FTI-TLP1 Type 1s - Vehicle Coverage & Preparation Notes

FTI-TLP1 Type 1s - Installation Notes & Wiring Diagram

Overview: The initial release of the FTI-TLP1 harness was produced without BCM CAN provisions for the TL2 vehicles. This issue affects the initial release and is already being addressed in production. A field correction procedure is detailed below in Figure 1.

Figure 1.

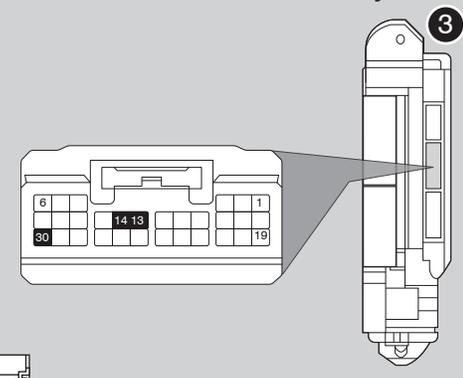
Issue: The TL2 junction connector does not include CAN connections that extend to the vehicle BCM. BCM connections are required for the 2018-19 Toyota Sienna. BCM CAN connections are available in both the TL6 & TL7 junction connectors, either pair can be relocated to the TL2 junction connector for this installation.

- 1.) TL2 junction connector with no CAN provisions
- 2.) TL6 & TL7 junction connectors with CAN provisions in pin position 2 (CANH) & position 8 (CANL)
- 3.) Remove harness covering to expose the CAN pair that you wish to relocate
- 4.) Use a pick tool to depress the locking tab on the terminal connector of the brown/yellow & brown/red wires (CANL & CANH)
- 5.) Remove each wire separately, relocate each to the matching position in the TL2 connector then secure the pair to TL2 branch
